SERVICE INSTRUCTION

Service Instruction No. 1047B
(Supersedes Service Instruction No. 1047A)
Engineering Aspects are
FAA (DEER) Approved

SUBJECT: Inspection and Reconditioning Procedures for Nitride Hardened Steel Cylinders

MODELS AFFECTED: All Avco Lycoming engines with nitride hardened steel cylinder barrels

Figure 1. Section Through Cylinder Assembly Showing Locations for Checking Diameter and Removal of Wear Step

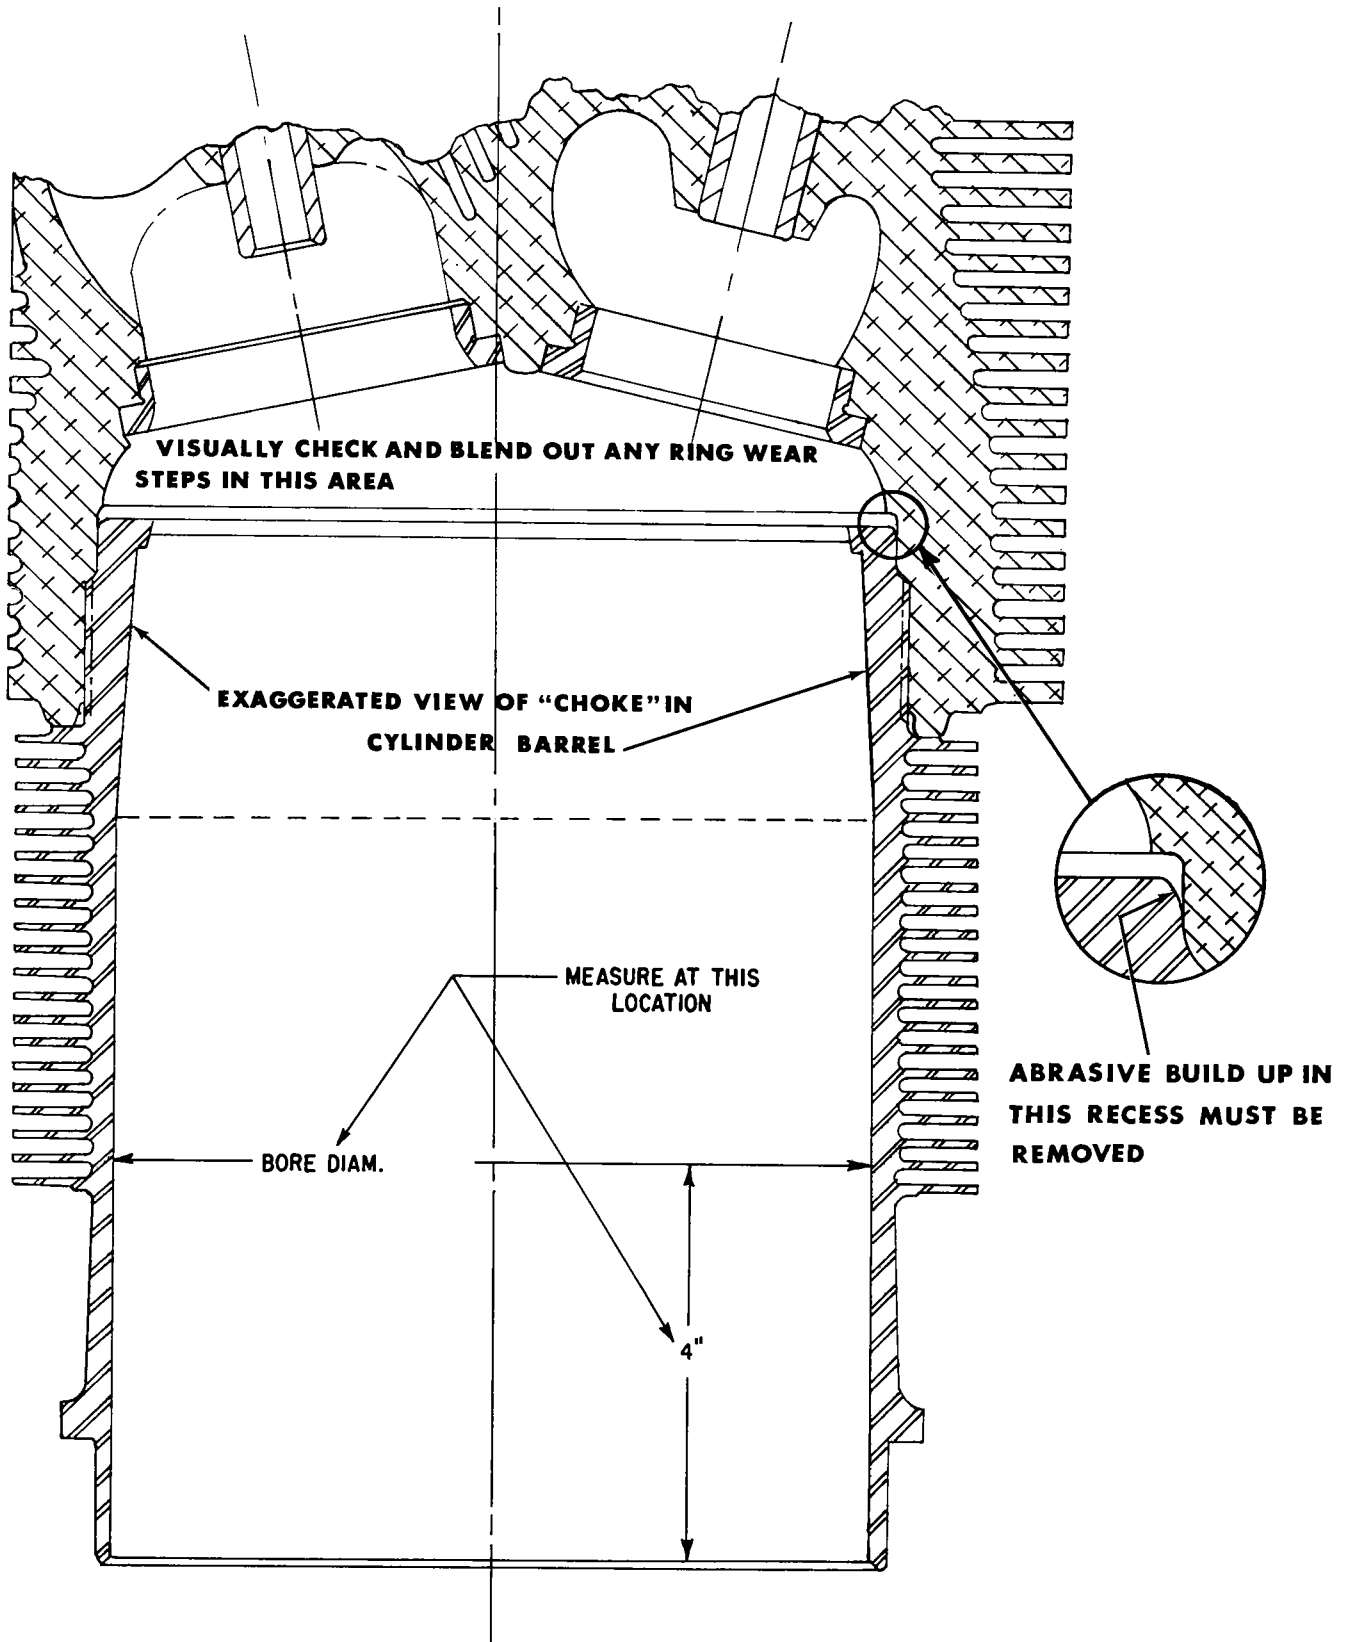
b. Dimensional Inspection:- Dimensional inspection of the cylinder barrel is limited to the area within four inches from the bottom of the barrel. See figure 1. A bore gage, with three points of contact and fitted with a dial indicator is preferable to an inside micrometer for measuring the cylinder barrel. Dimensional inspection of the cylinder barrel should be accomplished in accordance with the following description which explains how an average measurement can be made, thereby avoiding extremes that can occur when only a single measurement is taken. The diagram, figure 2, illustrates the following description. To measure cylinder diameter:

f. When de-glazing procedure has been accomplished, wipe as much as possible of the abrasive build-up from cylinder walls and recesses. Pay particular attention to recess formed by top of cylinder barrel and bottom of cylinder head. Fabricate a hooked tool from soft wire and run the tool around in the recess to loosen build up of abrasive. This operation must be performed each time the cylinder is flushed. No abrasive must remain in this area. See figure 1. Proceed to clean cylinder as follows:

Figure 2. Diagram of Cylinder Barrel Showing Locations of Measurements

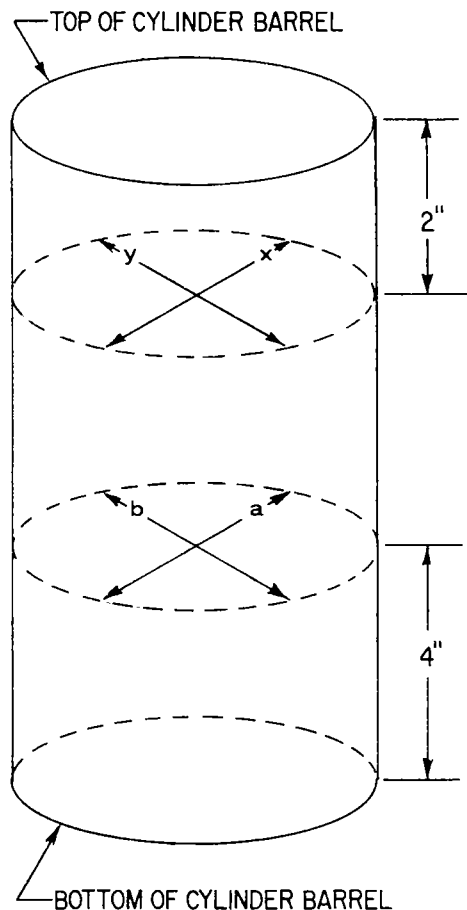
(1) Measure diameter a and diameter b at 90° from each other, 4 inches above the bottom of the cylinder skirt.

(2) Add diameters a and b and divide the sum by 2 to obtain the average diameter.
for example: a = 5.1285
b = 5.1315

$$\frac{a + b}{2} = \frac{5.1285 + 5.1315}{2} = \frac{10.260}{2} = 5.130 \text{ in.}$$

To measure cylinder taper:

Determine average diameter at lower portion of the barrel as described above. Then determine average diameter at the top of the barrel (about 2 inches from the top). The difference between the two average diameters represent the average taper of the barrel.

$$\frac{a + b}{2} - \frac{x + y}{2} = \frac{5.131 + 5.132}{2} - \frac{5.1285 + 5.1315}{2} =$$

$$5.1315 - 5.13 = .0015 \text{ inch taper}$$

To measure cylinder out-of-round:

Subtract diameter a from diameter b; also subtract diameter x from diameter y. Add the remainders and divide by 2.

$$\frac{(a - b) + (x - y)}{2} = \frac{.003 + .001}{2} = \frac{.004}{2} = .002 \text{ in.}$$
